STAFF RECOMMENDATION
1907 Beechwood Avenue
January 20, 2016

Application: New construction - addition

District: Belmont-Hillsboro Neighborhood Conservation Zoning Overlay

Applicant: Chris Holt, Holt Construction Group; Jennifer Cassani, Property Owner

Structural Letter for Roof Modification 1907 Beechwood Renovation – Nashville, TN

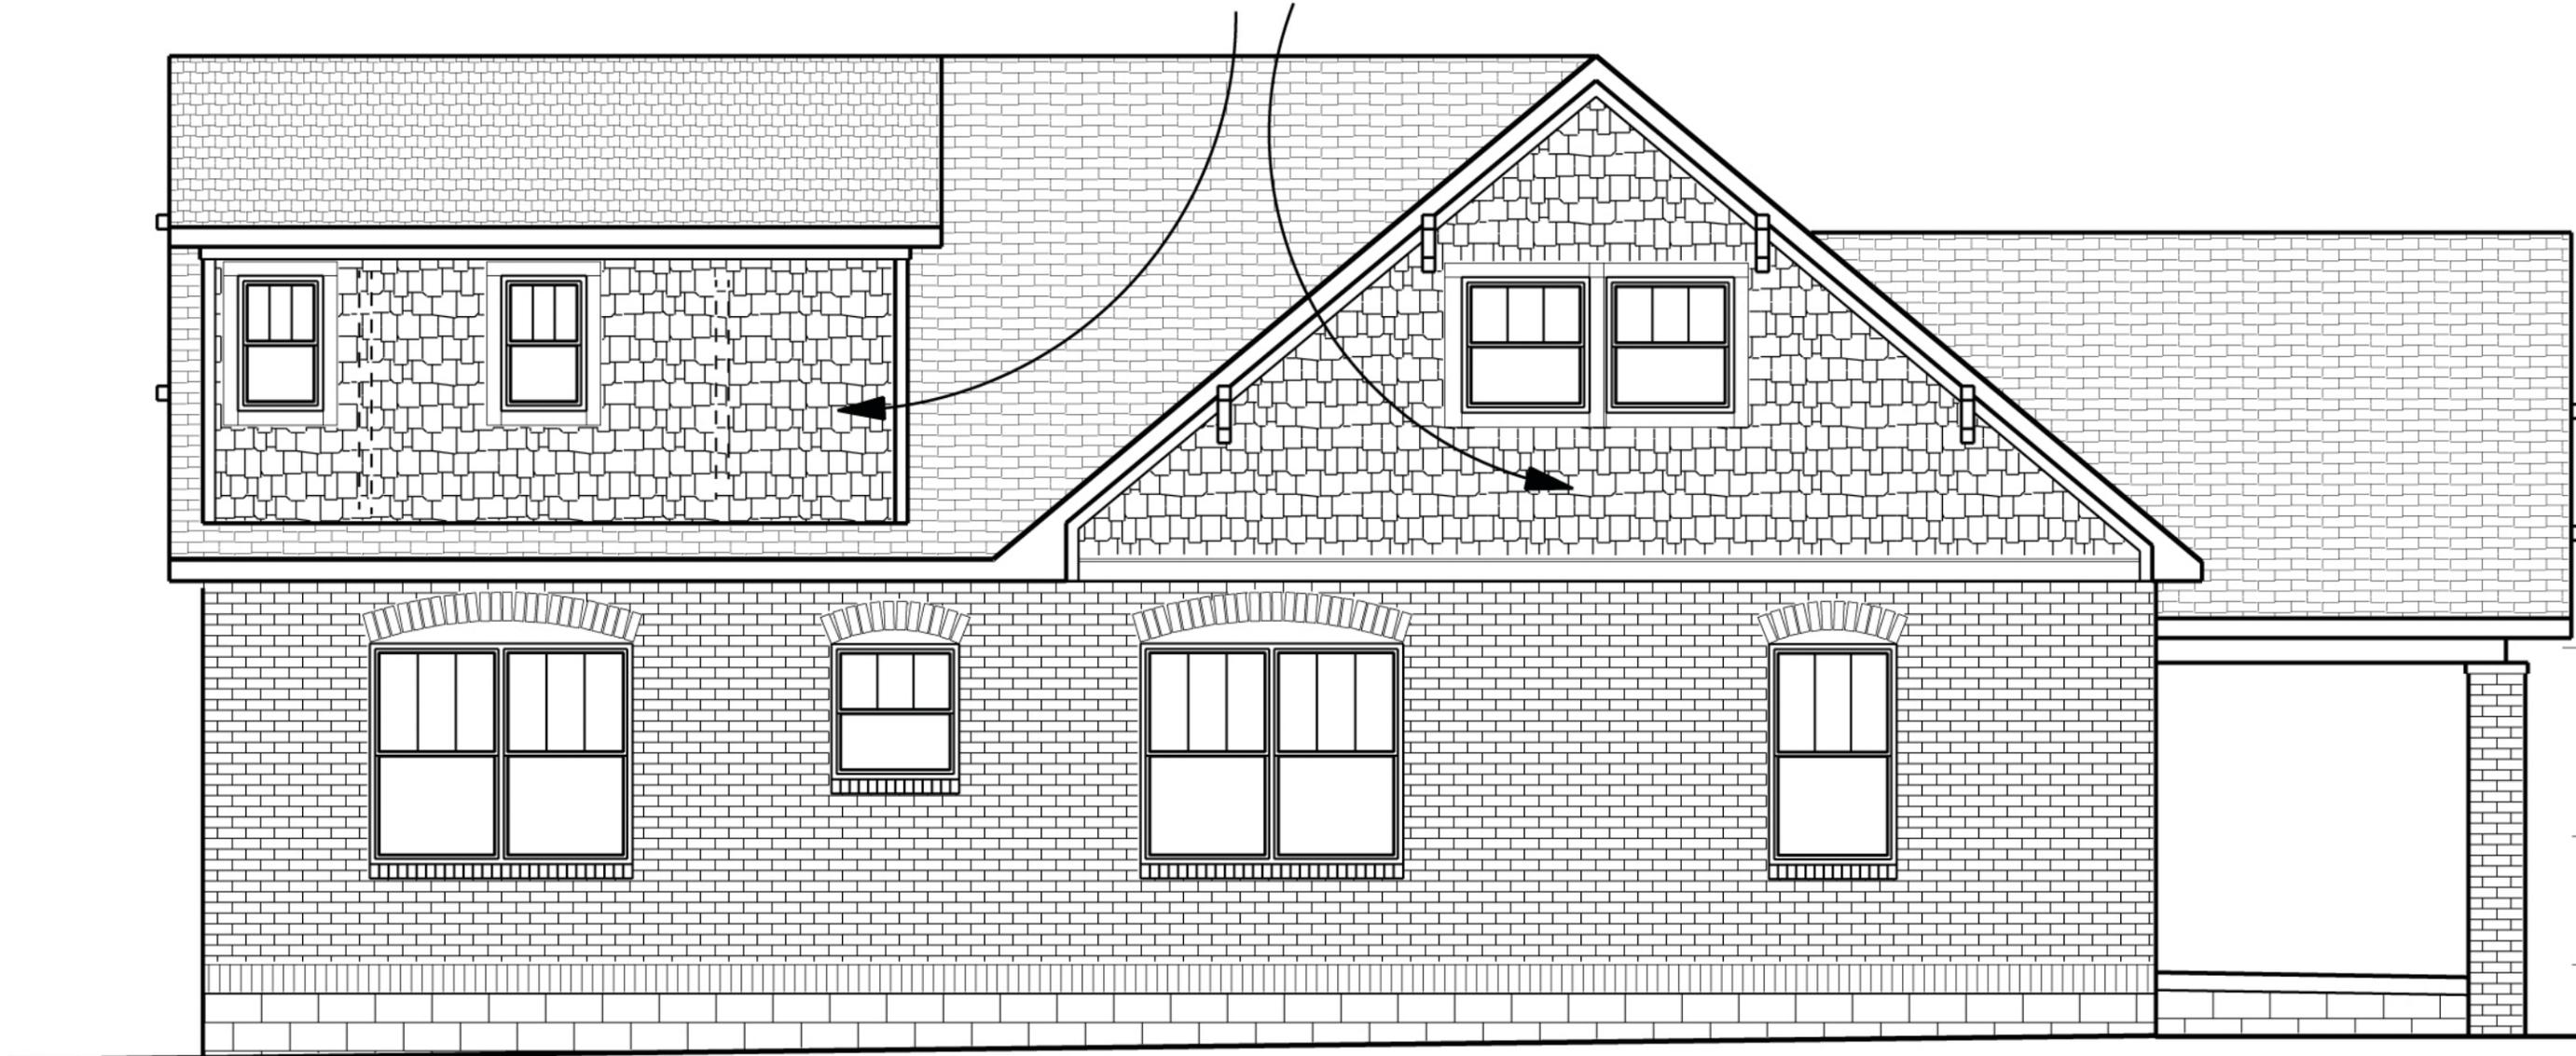
JRE has made several visual field observations of the existing house structure. The structural components were observed as wood roof rafters at 24" nominal spacing and wood attic floor joists at 16" nominal spacing. The roof and floor members bear on the existing exterior wood stud wall. It is my understanding that a request has been made to offset the upper roof support to the house interior (roof bearing will not line up with the wall below.)

JRE does not recommend that this offset roof condition is to be installed. Our structural concerns are the following.

1. Exterior wall movements with temporary supports on wall alignment and finishes.
2. Diaphragm forces transferred thru the existing roof and floor system to shear walls.
3. Lateral stability of the house in the temporary and the permanent conditions.
4. Attic floor framing capability to support the new roof framing condition.
5. Removal of structural members may adversely affect historical exterior look.

LEFT ELEVATION

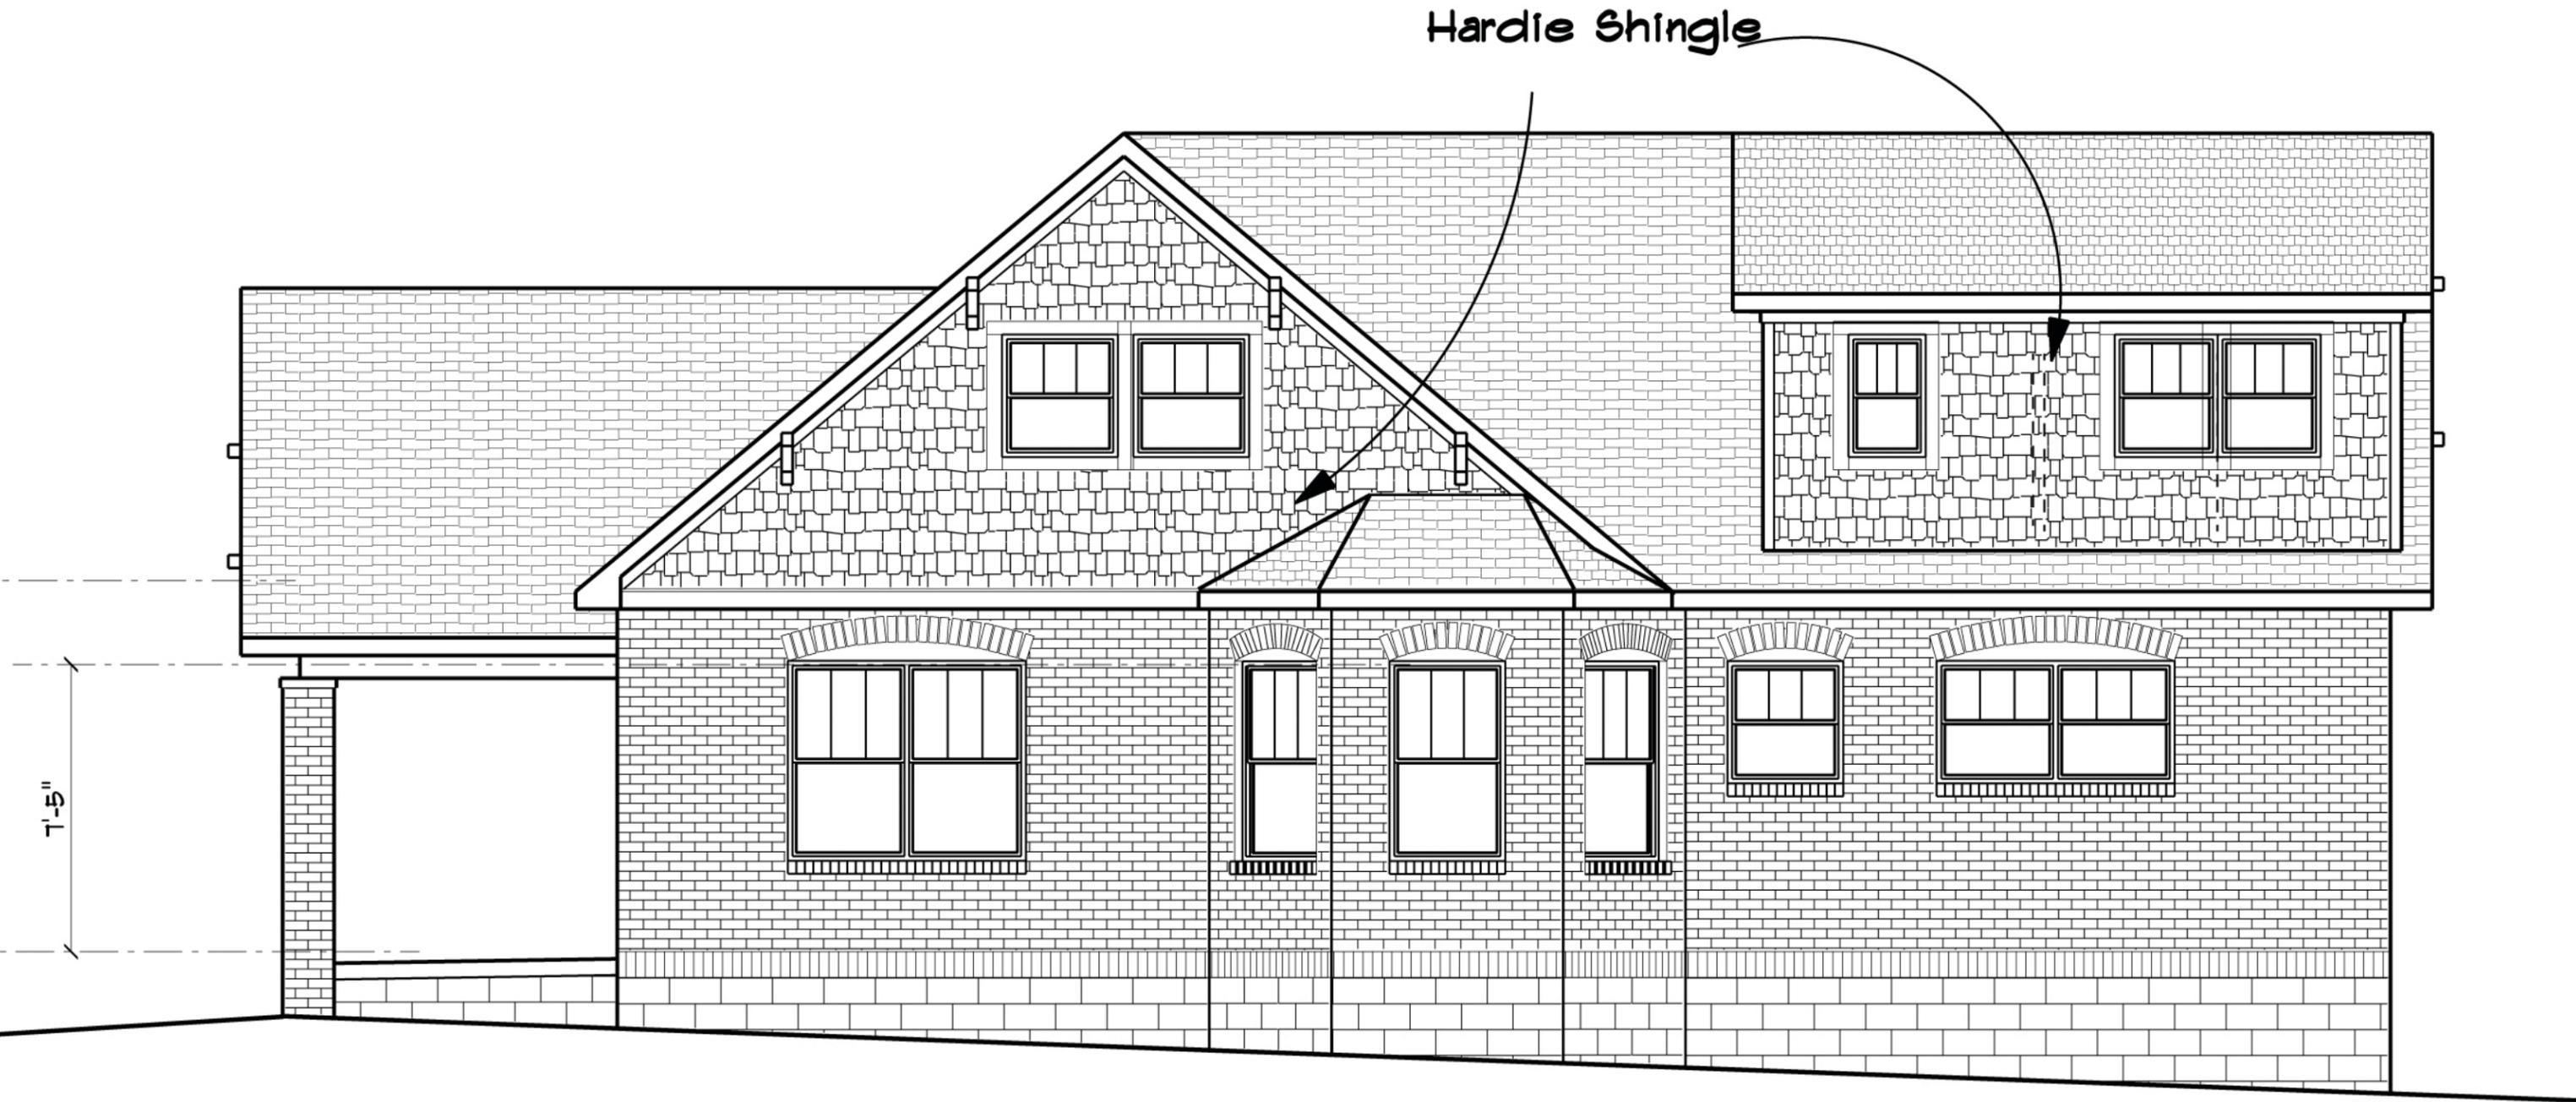
The proposed new dormers will be located thirty feet (30') back from the front wall of the building and will tie into the existing roof at the ridge, with the side walls aligned directly above the first story walls of the house.

To date, the Commission has consistently required upperstory additions to sit in two feet (2') from the side walls of historic houses. Setting in the side walls helps to reduce the visibility and impact of dormer additions, and it is more compatible form because the vast majority of dormers were also set in historically. Staff finds that in not setting in the upperstory walls, this would effectively create a two-story addition behind a one-story house.

Finding that the proposed dormers would not be compatible with surrounding historic buildings and would not meet sections II.B.2.a and II.B.2.e of the design guidelines, staff recommends a condition that the dormers sit in two feet (2') from the wall below and that new drawings be submitted prior to the issuance of a permit.

Staff recommends approval of the proposal to construct dormers at 1907 Beechwood Avenue with the conditions that the dormers sit in two feet (2') from the side walls of the existing building, and that the window selections are approved by MHZC Staff prior to selection. Meeting those conditions, Staff finds that the proposal will meet the applicable design guidelines for additions in the Belmont-Hillsboro Neighborhood Conservation Zoning Overlay.
